RE: Draft White Paper on TVA's Kingston Ash Failure

BY: Barry Thacker, P.E.
barryt@geoe.com

Figure 1. Results of stability analysis for undrained shear strength of sluiced ash = 700 psf and minimum factor of safety less than 1.0 according to the undrained failure theory suggested by TVA's forensic team at Kingston

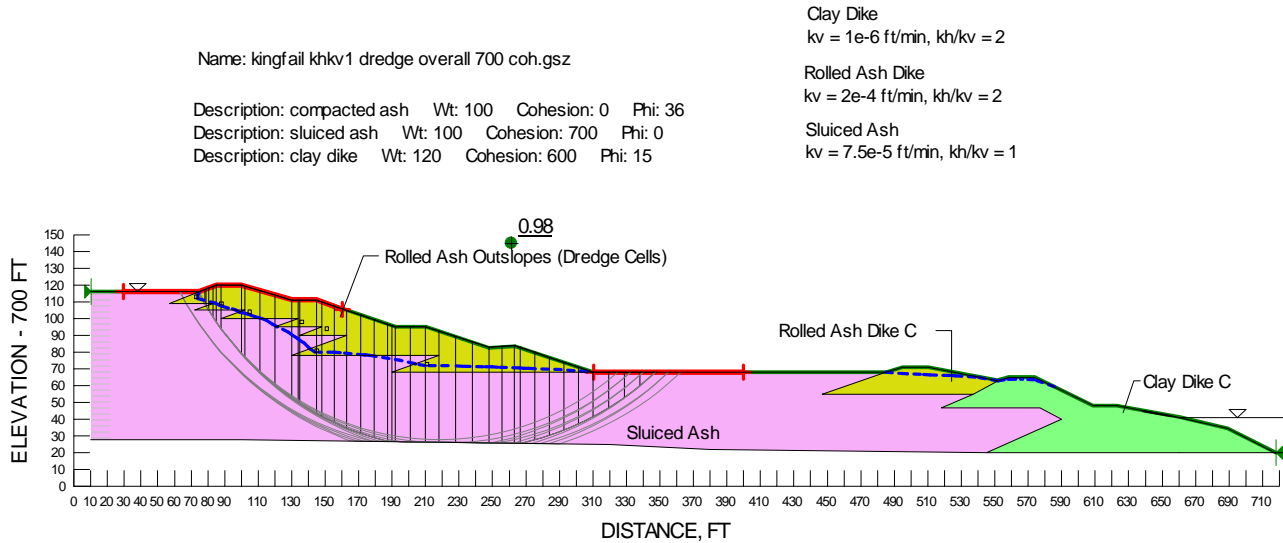
Figure 1 shows the results of a stability analysis that back-calculates average undrained shear strength = 700 psf for the sluiced ash and ash/sediment layer as being required to produce a factor of safety less than 1.0. Figure 2 illustrates that a zone at the base of the sluiced ash with undrained shear strength = 600 psf could produce failure presuming the overlying sluiced ash has undrained shear strength = 725 psf.

Figure 10. Results of stability analysis for effective stress condition with $k_h/k_v = 100$ in sluiced ash and minimum factor of safety = 1.61 for Dike C hinge area (for case with sluiced ash elevation = 768 feet before construction of Kingston Dredge Cells)

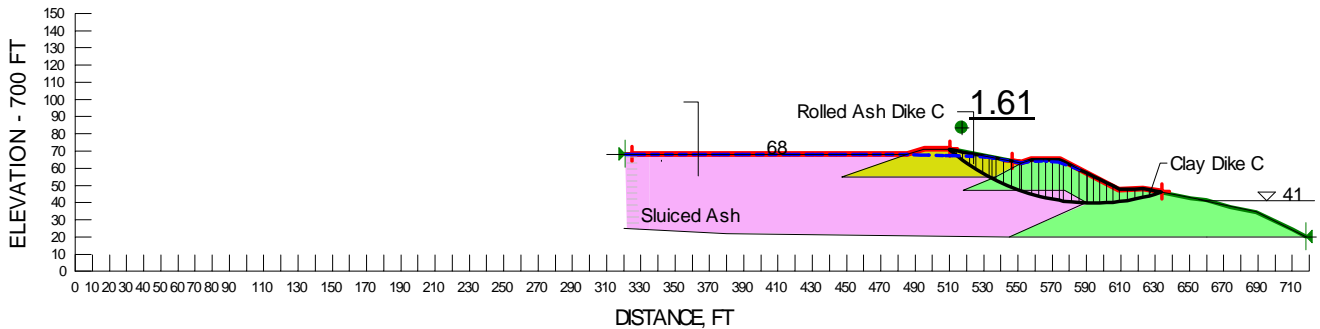
With regard to stability, a computed factor of safety greater than 1.5 is predicted in the hinge area of Dike C prior to construction of the dredge cells, when the level of the sluiced ash is at elevation 768 feet, as shown on Figure 10. When the sluiced ash in the dredge cells is at elevation 809 feet in the model, the computed factor of safety of Dike C is slightly greater than 1.0 as shown on Figure 11 and failure is still not predicted; however, when the sluiced ash reaches elevation 816 feet in the dredge cells, as it did on 22 December 2008, the model accurately predicts failure with a factor of safety less than 1.0 as shown on Figure 12.

Figure 14. Illustration of possible scenario of failures, as triggered by Dike C rupture, based on results of steady-state seepage and stability analysis for effective stress conditions

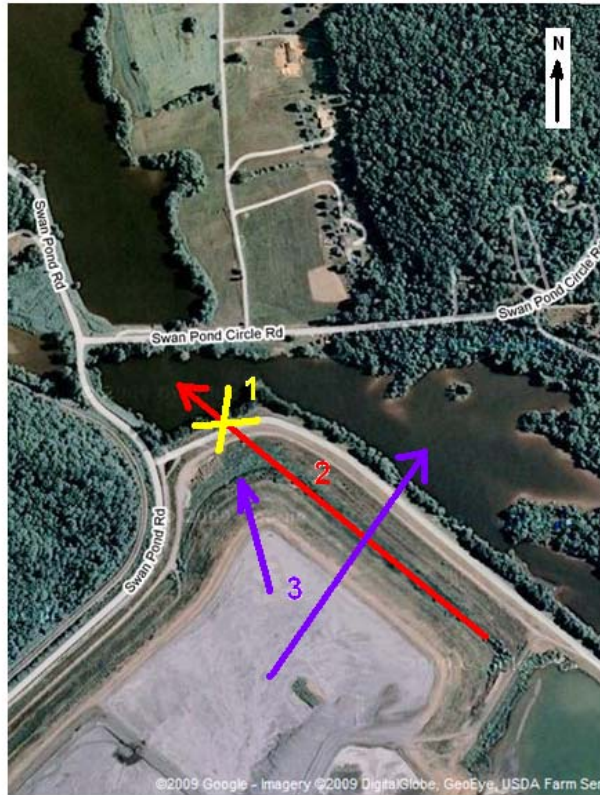
One explanation is that Dike C ruptured at its northwestern limb. The excess pore water seepage pressure could then relieve itself through the breach, resulting in the failure of the sluiced ash between Dike C and the downstream toe of the dredge cells in a northwesterly direction. Subsequent failure of the dredge cells due to undermining of its foundation could then have progressed in a northeasterly direction, as would be expected, with subsequent spreading of the failed material due to gravity after it reached Watts Bar Lake. The sequence of the failure, based on the results of steady-state seepage and stability modeling according to effective stresses and post-failure aerial photographs, is shown on Figure 14.

Based on a cursory review of TVA's forensic study report, the relic survey corroborates the failure scenario triggered by the Dike C rupture shown on Figure 14. Nevertheless, the results of my analysis need to be tested against additional field evidence not available to me. Were any of the "old dewatering wells" and "dewatering well overflowing redwater" referenced in the 2009 inspection report located in Dike C? Were any piezometers installed beneath Dike C within the failure zone, and were any of those piezometers being monitored? Could the references to "redwater" indicate the presence of iron from pyrites in the ash? If so, did the dewatering wells eventually clog due to iron deposition, thus reducing their effectiveness? When the valves were closed on the dewatering wells during the October 2008 inspection, what water levels were measured and were the valves re-opened after the inspection?

Figure 15. Results of stability analysis for Dike C using undrained strength as suggested by TVA's forensic team with computed minimum factor of safety = 1.51, which indicates stable condition, whereas steady-state seepage and stability analysis using effective stresses predicts failure.

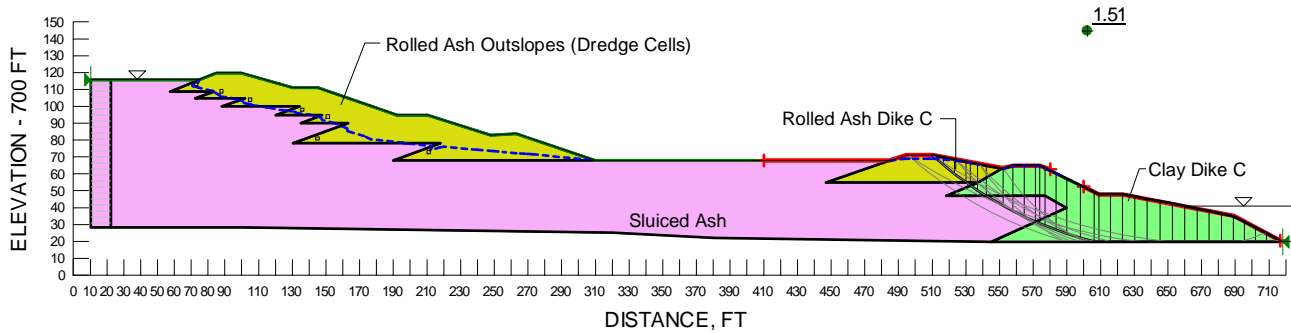
Ironically, a stability analysis performed using undrained strength, as suggested by TVA's forensic team, incorrectly predicts a stable Dike C regardless of the pore water pressure in the sluiced ash as shown on Figure 15.

Answers to these and many other questions are important, and will undoubtedly foment new questions that need answering in order to understand the cause of the Kingston failure so such situations can be avoided or mitigated in the future. As illustrated by Figure 15, use of undrained shear strength to analyze the stability of undrained hinges at other hydraulic fill sites as suggested by TVA's forensic study report is dangerous and not recommended.
